**BOARDING HOUSE  
(KERR HOUSE)**

30 KERR PDE  
AUBURN NSW 2142 AUSTRALIA

Status  
**DEVELOPMENT APPLICATION**

Drawing Title  
**FLOOR PLANS**  
**LEVEL 06**  
Checked/Approved

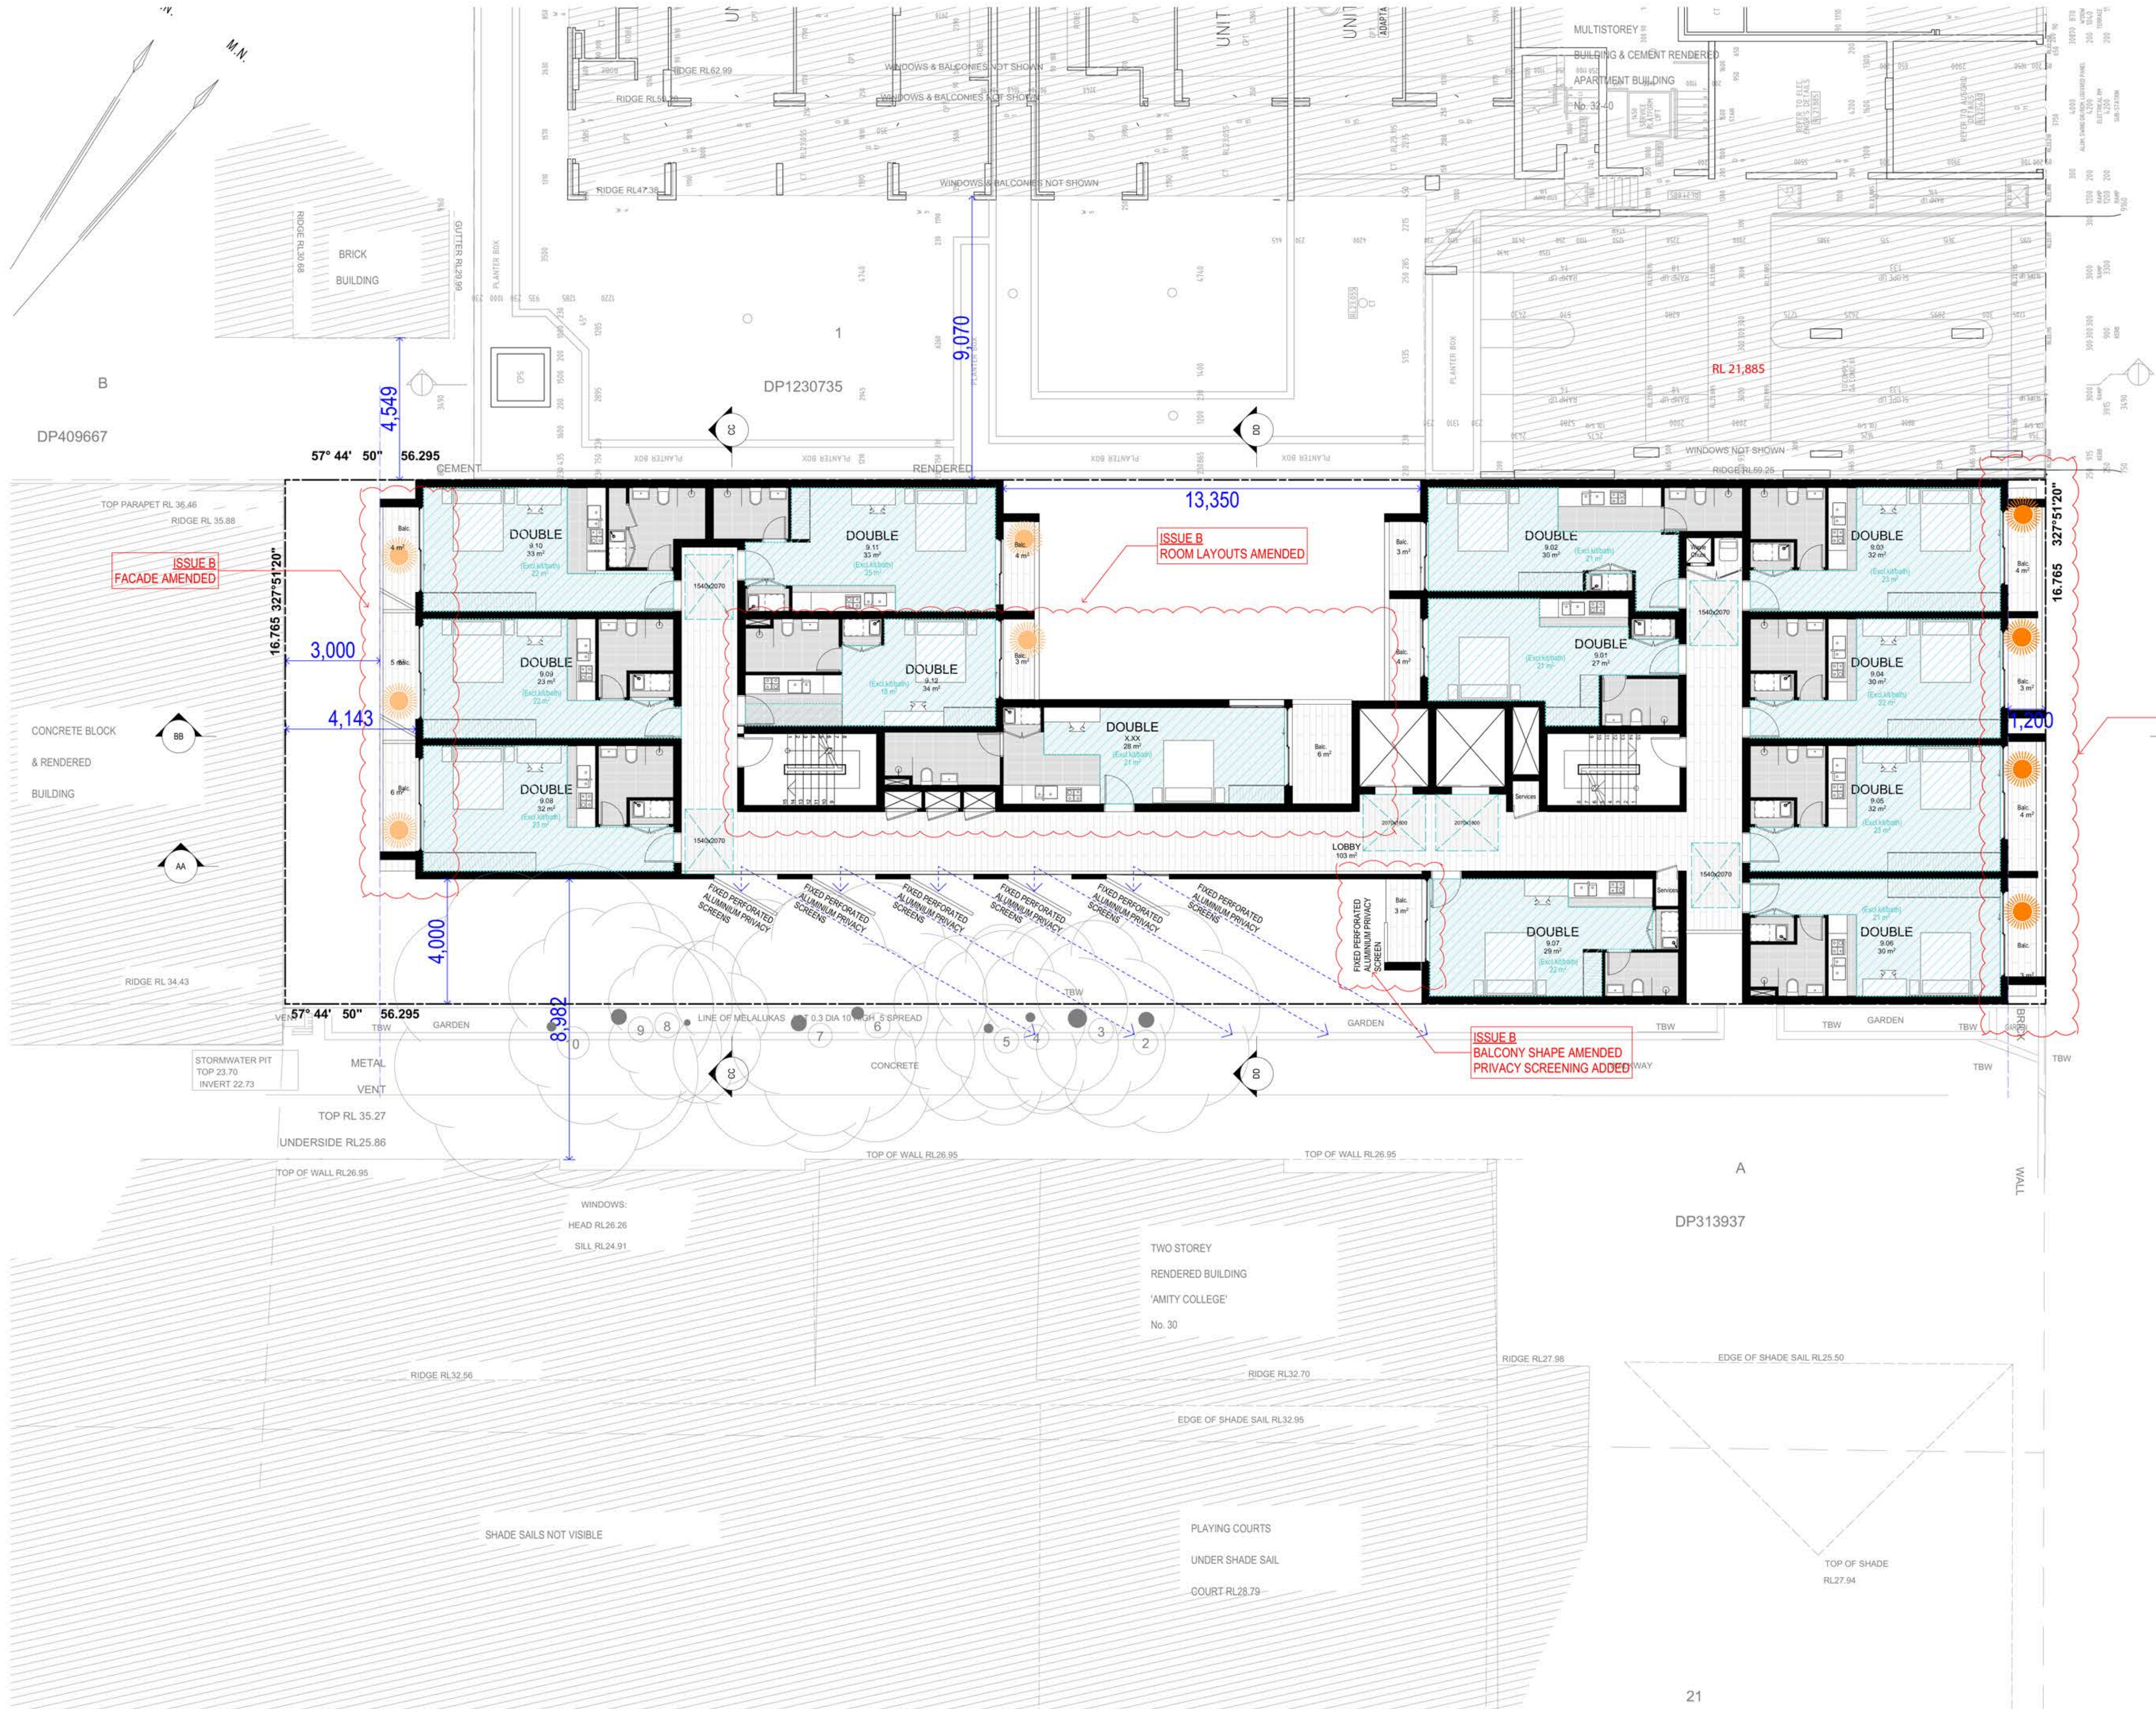
ISSUE B  
FACADE AMENDED

ISSUE B  
BALCONY SHAPE AMENDED  
PRIVACY SCREENING ADDED

Drawing Title  
**FLOOR PLANS**  
**LEVEL 07-09**  
Checked/Approved

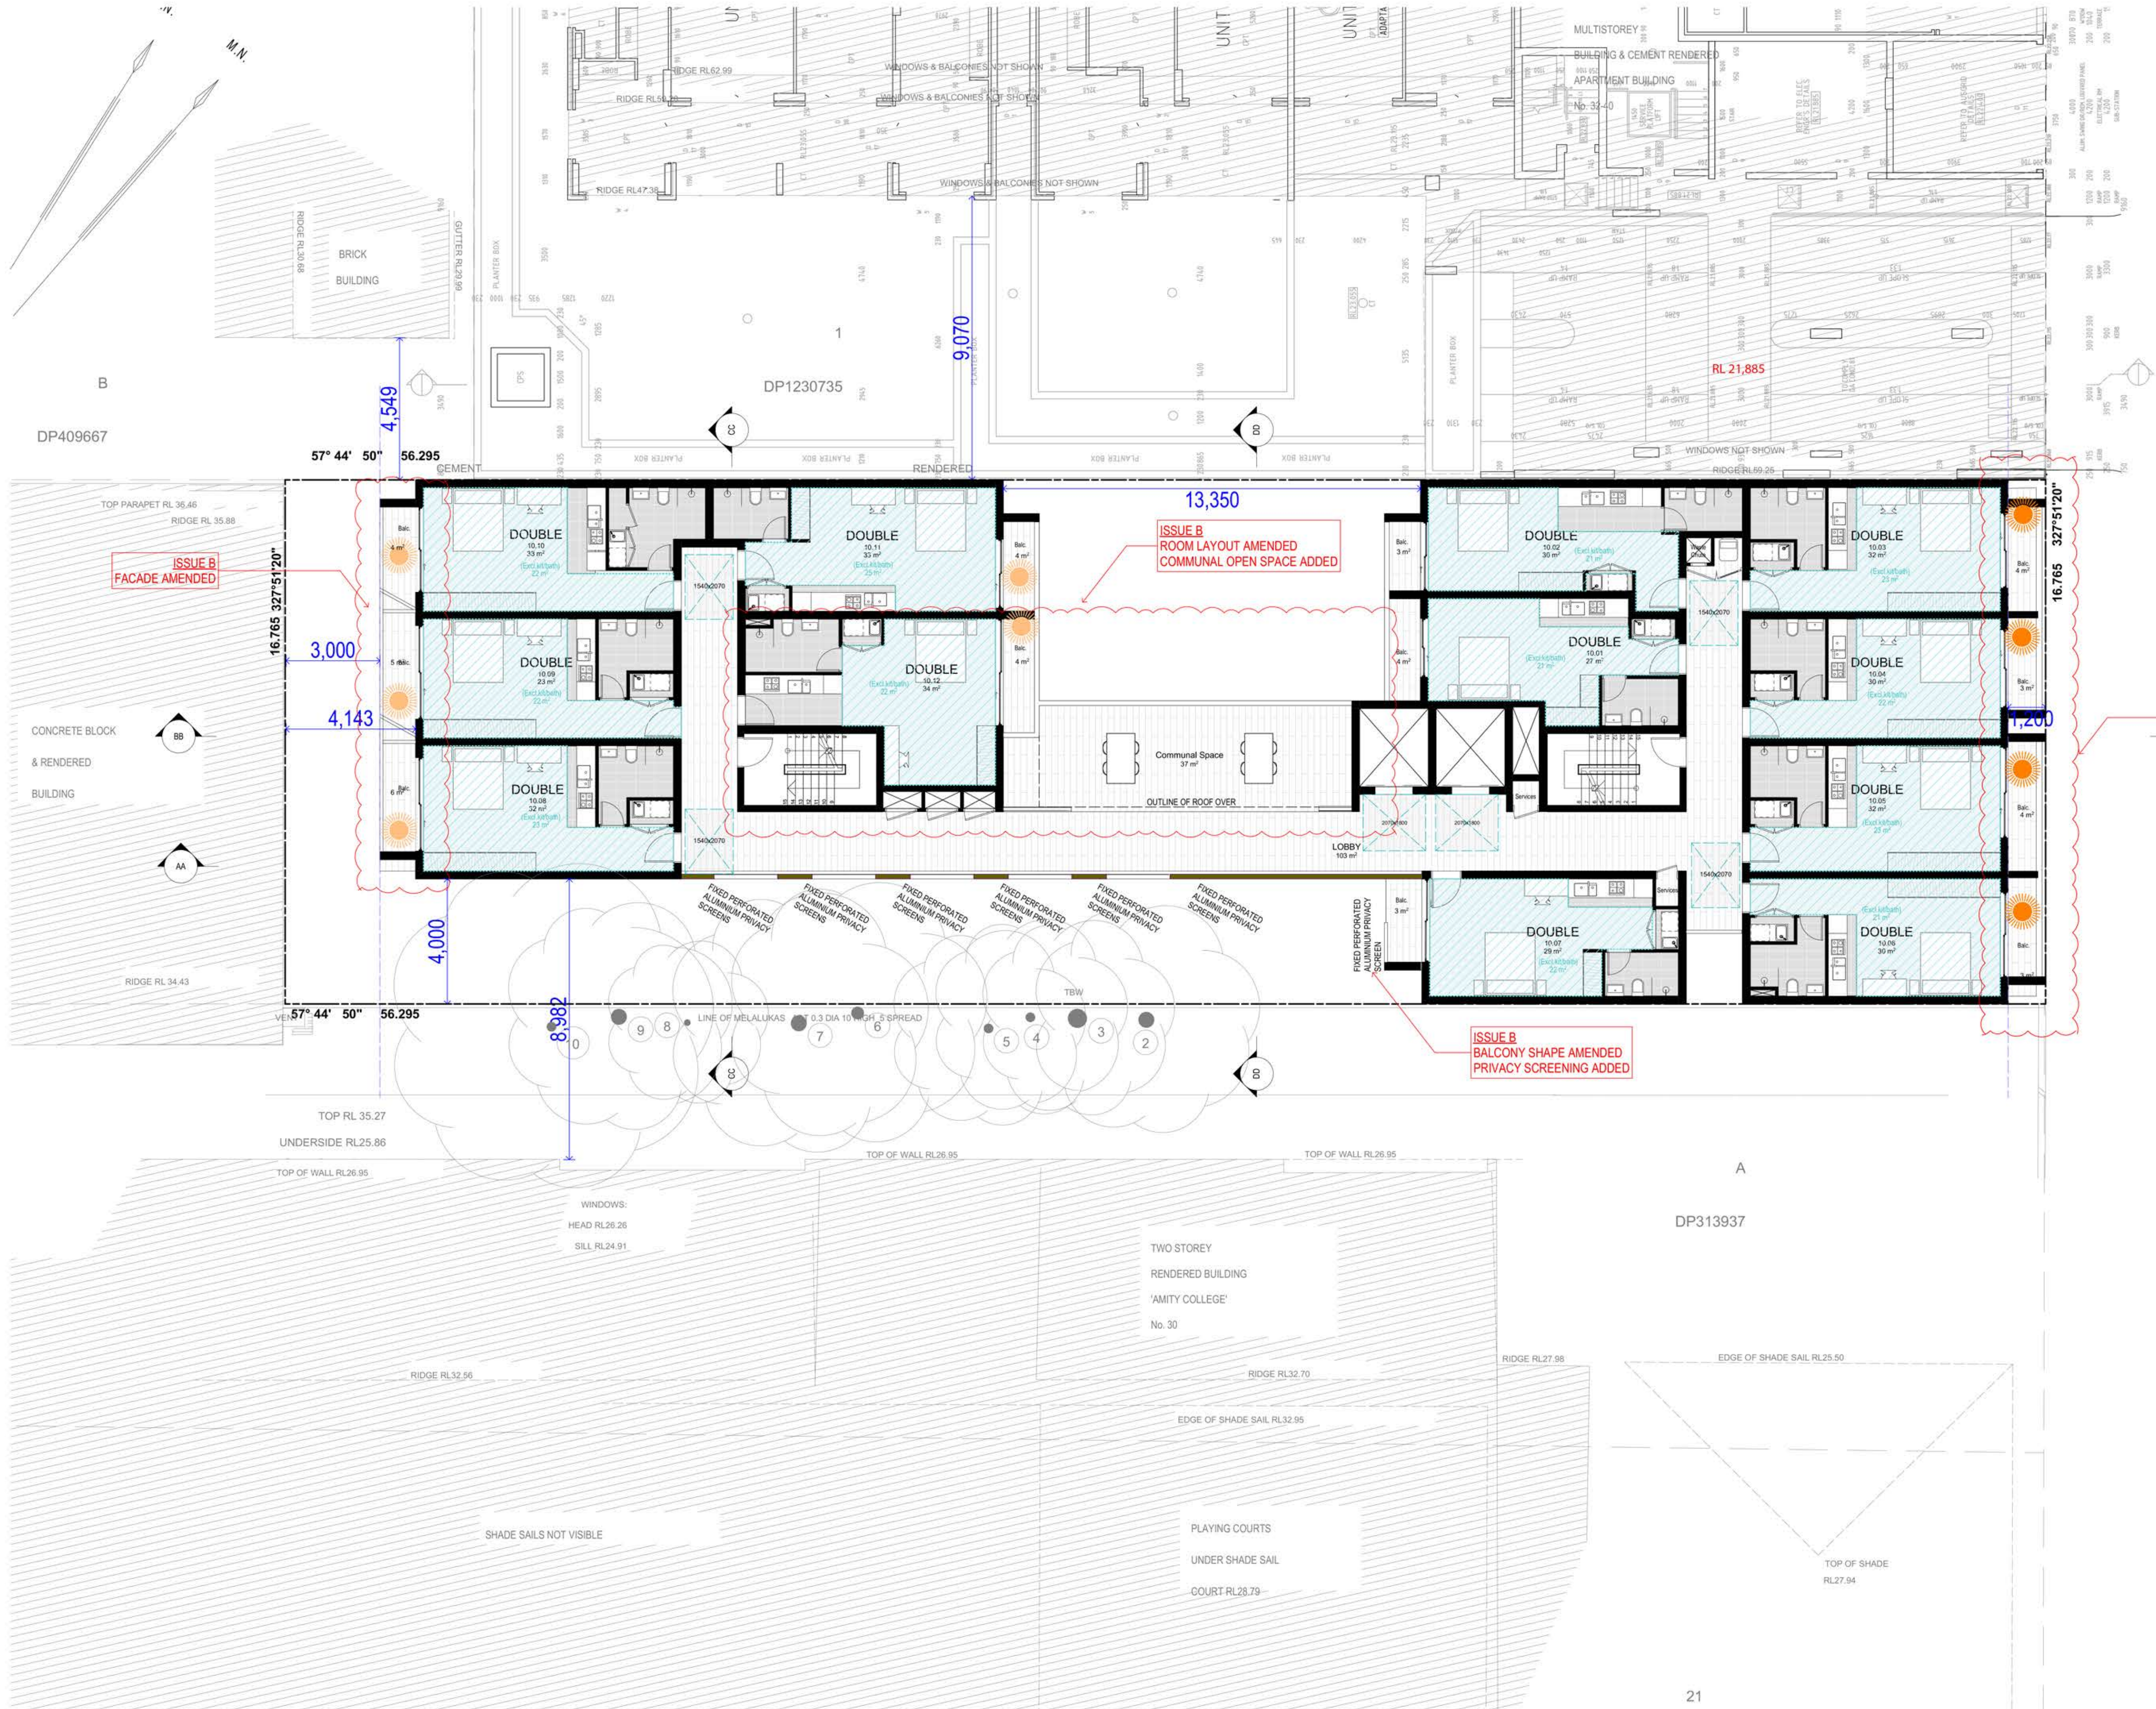
ISSUE B  
FACADE AMENDED

ISSUE B  
BALCONY SHAPE AMENDED  
PRIVACY SCREENING ADDED

ISSUE B  
ROOM LAYOUT AMENDED  
COMMUNAL OPEN SPACE ADDED

ISSUE B  
FACADE AMENDED

Drawing Title  
**FLOOR PLANS**  
**LEVEL 10**  
Checked/Approved

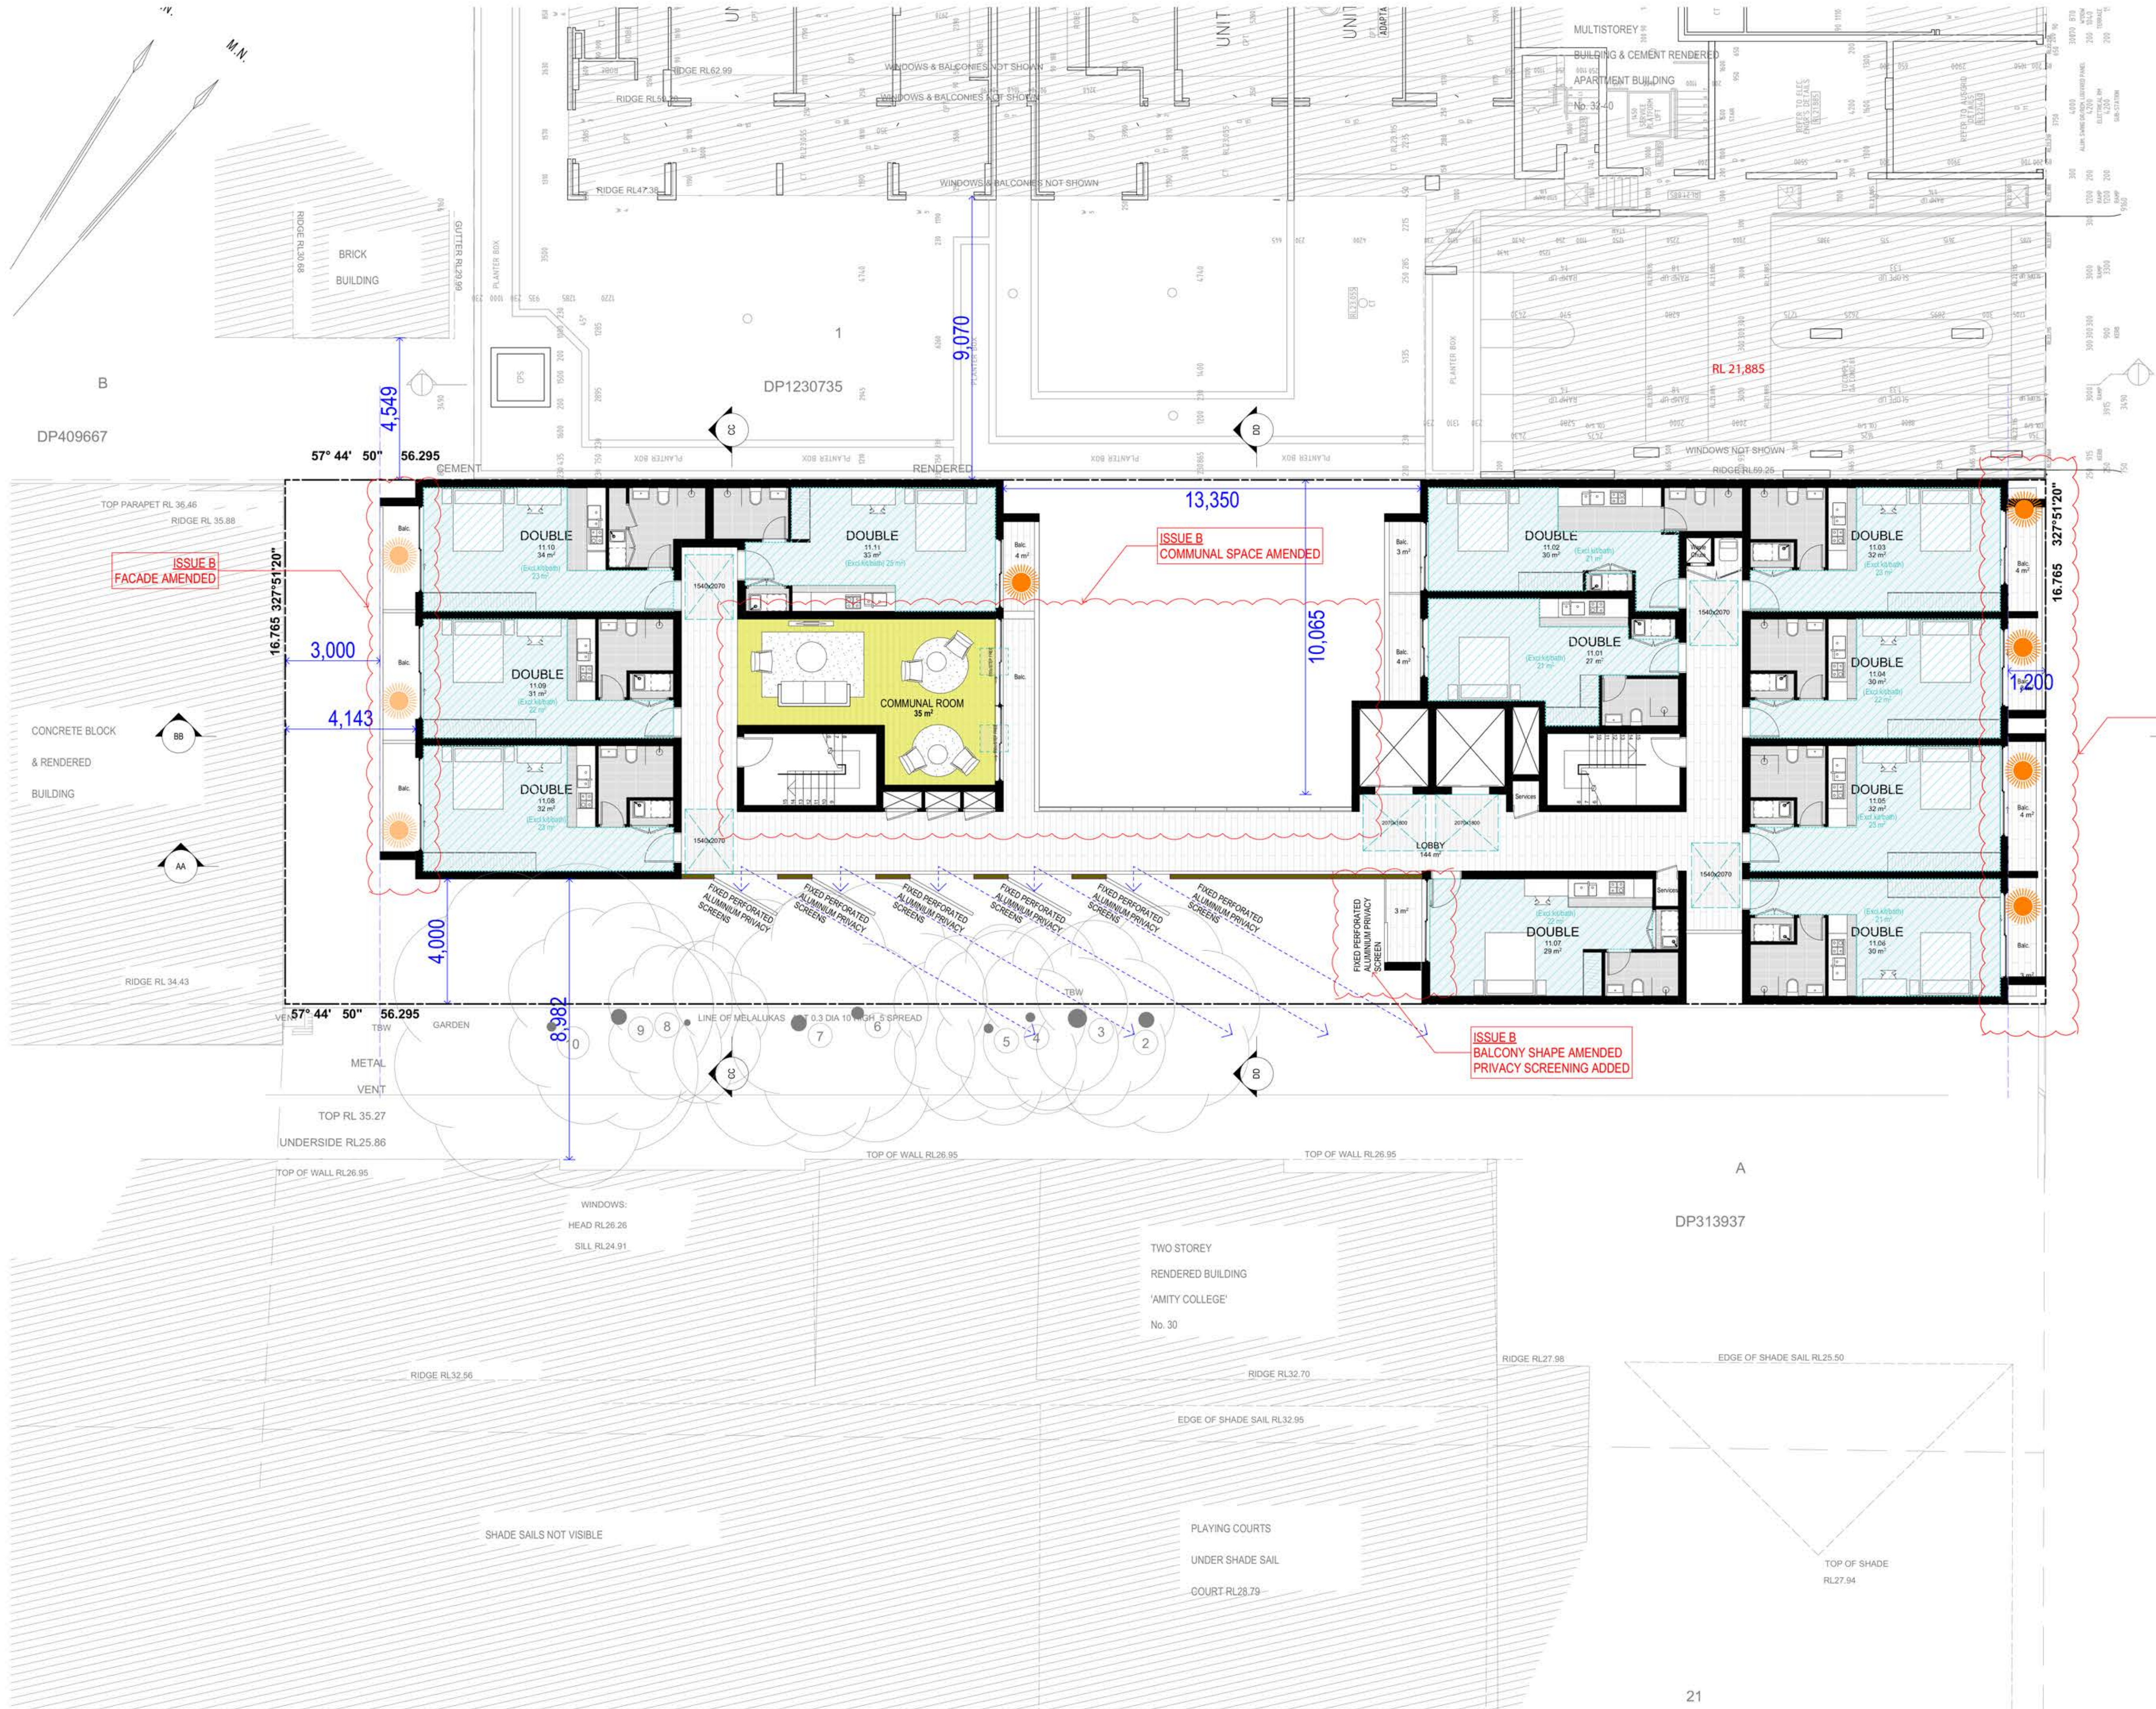
ISSUE B  
FACADE AMENDED

ISSUE B  
BALCONY SHAPE AMENDED  
PRIVACY SCREENING ADDED
